MATANUSKA-SUSITNA BOROUGH

ABBREVIATED PLAT AGENDA

June 4, 2025

STAFF REVIEW AND RECOMMENDATIONS
PUBLIC HEARING
JUNE 4, 2025

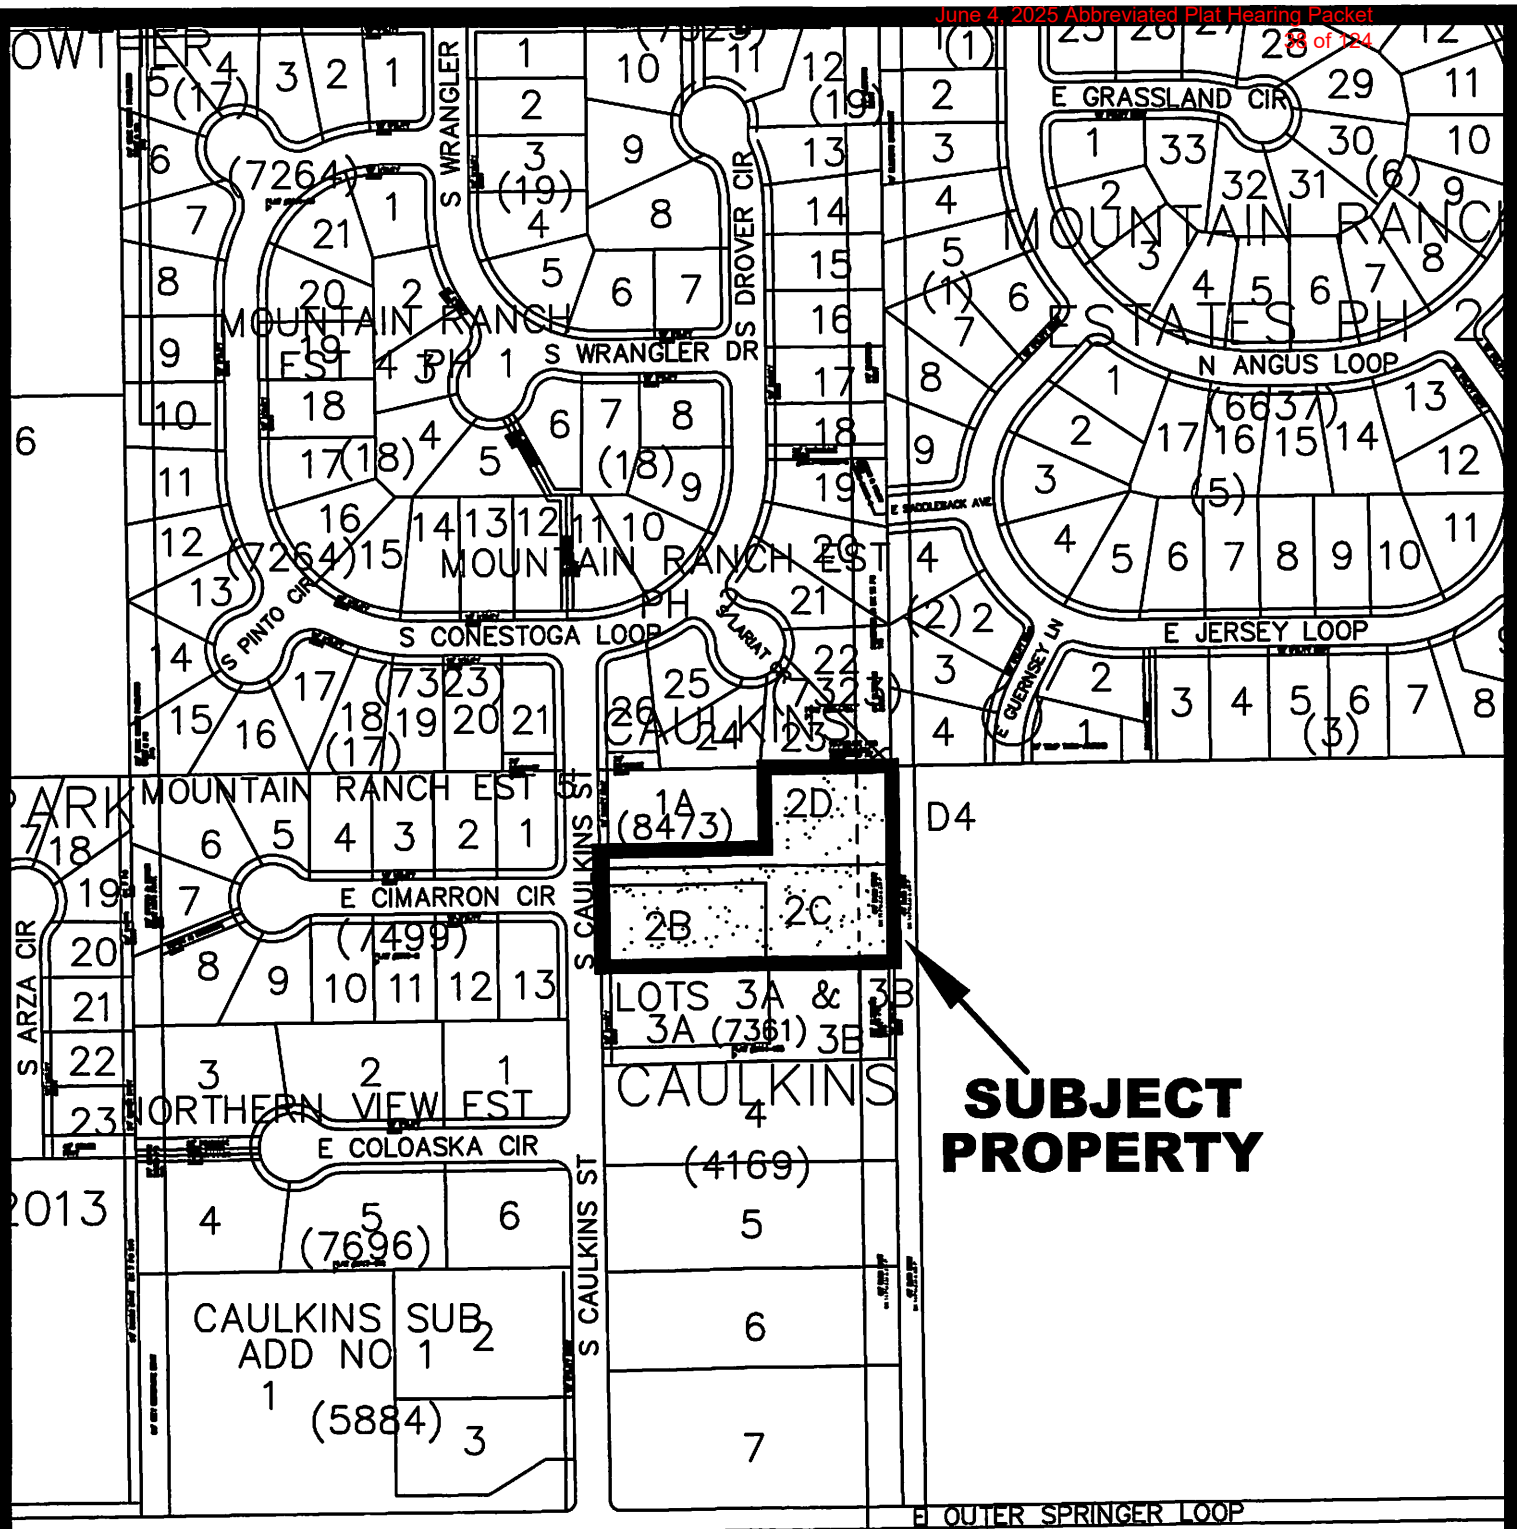
1. Add a note which says, "There is a ten foot (10 FT) wide natural gas easement centered on the existing service line." And draw in the location of the service line on the map and add, "Location of natural gas service pipeline and centerline of ten foot (10 FT) wide natural gas easement".
2. Owner signs an ENSTAR Natural Gas Easement Document for a ten foot (10 FT) wide natural gas easement, centered on the service pipeline at this location.

3. Overlay the flag pole portions of Lots 2C and 2D with a common access easement.
4. Remove/relocate the shed located on the proposed lot line between Lots 2C and 2D. Provide platting staff either an updated as-built or a letter from a surveyor certifying that no setback violations exist, nor are any being created by this platting action.

5. Record an easement with ENSTAR for the existing service line. Show the recorded easement information on the final mylar.
6. Pay postage and advertising fees.
